**Holy Family Cemetery
Crematorium Building
2523 Lower Base Line Road, Milton ON**

ELECTRICAL ADDENDUM #E2

HOLY FAMILY CEMETERY
CREMATORIUM
2543 LOWER BASE LINE ROAD
MILTON, ONTARIO

ROOM FINISH AND DOOR SCHEDULES

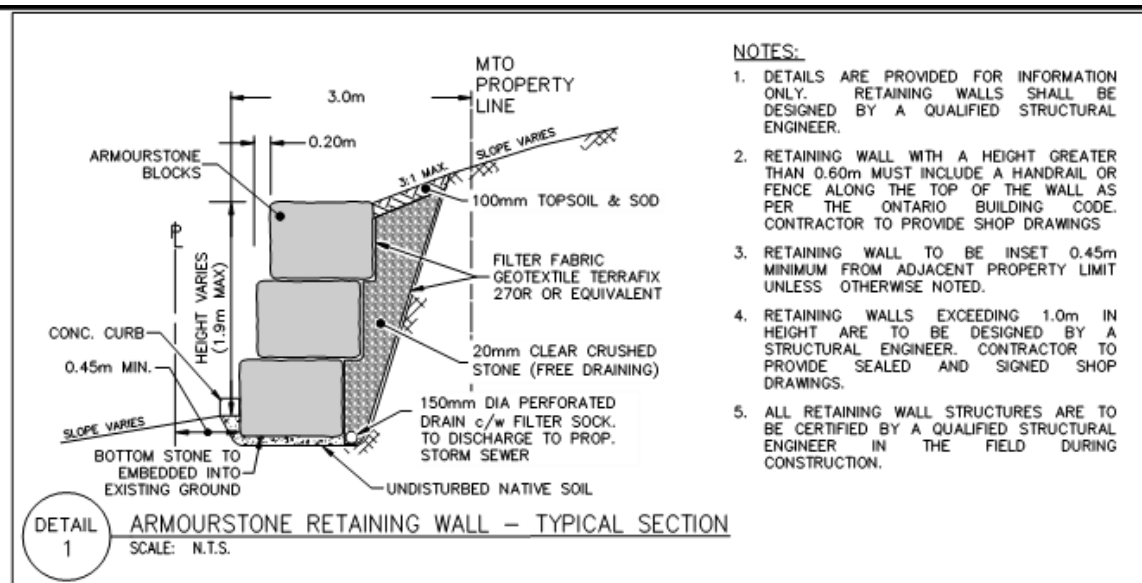
Please provide a detail of armourstone retaining wall/wingwalls at culvert and a spillway that are shown on drawing C108.

The armour stone is to be installed at a 3:1 side slope to existing grades and as per the detail below.

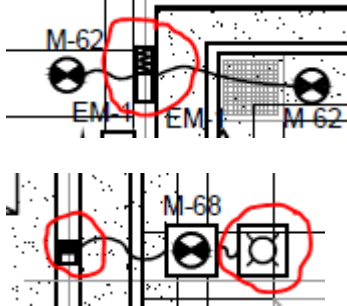
Also, I didn't find any legends stand for the following things on the drawing:

Refer to electrical addendum E2.

SCALE: AS NOTED	PROJECT: 2019-08
START DATE: OCT. 2019	DRAWING: A8.00
DRAWN: D.W.	CHECKED: J.G.
PRINT DATE 10/16/23

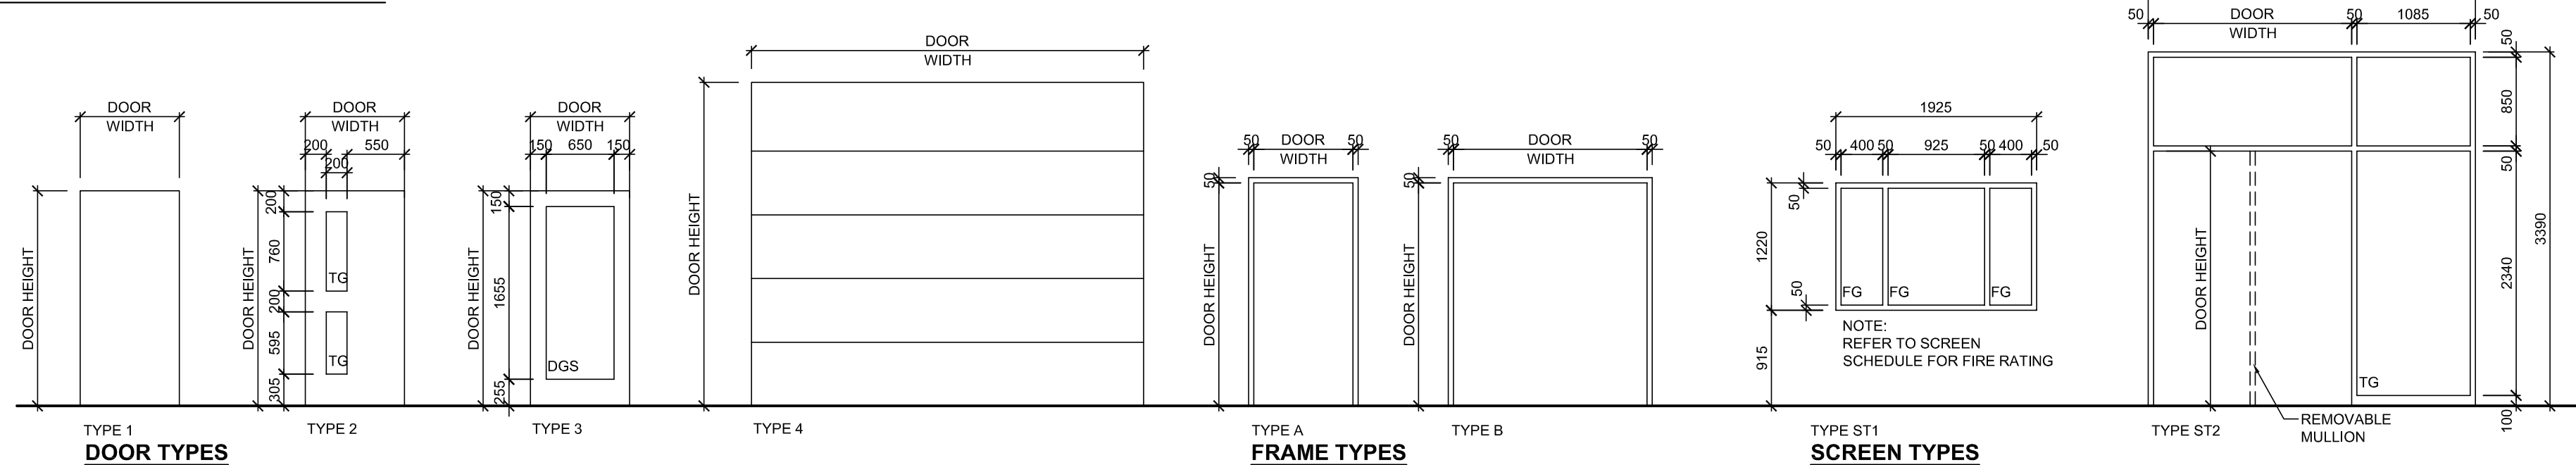
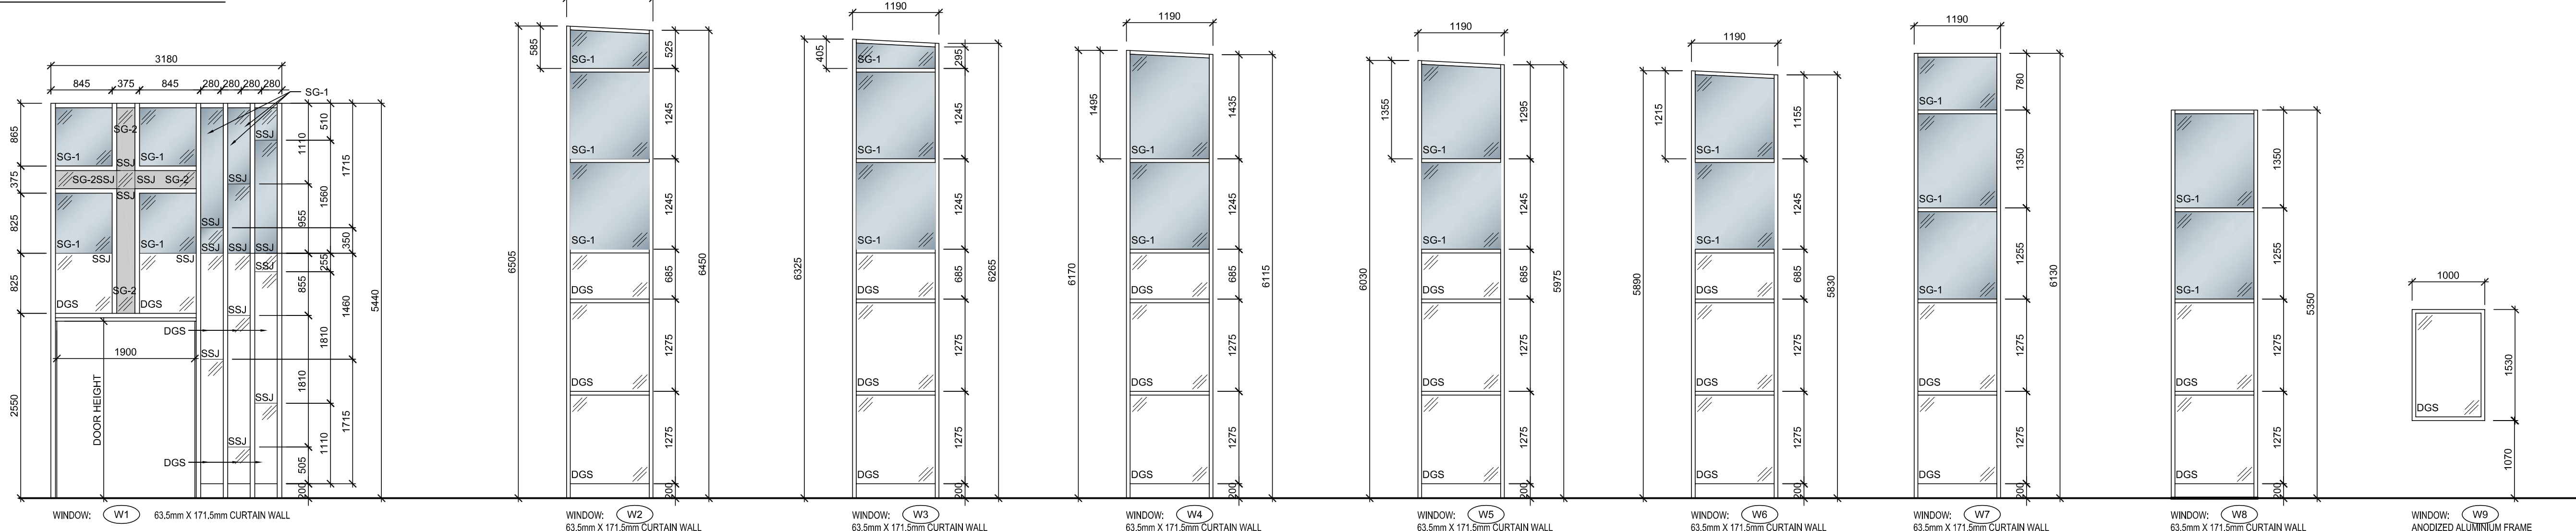
- Item 2** Specifications Section 00200 Instructions to Bidders
Under item 12. Qualifications, **delete** subitem 3 Subcontractors in its entirety.
- Item 3** Refer to attached A8.00. **Door 103A** has been revised to a **solid core wood door with a plastic laminate finish.** The finish for **doors 107A, 108A, 109A, 109B, 111A and 112A** has been **revised to plastic laminate.** The legend has been updated to include abbreviations for **Plastic Laminate (PLAM)** and **sealed concrete (SC).**
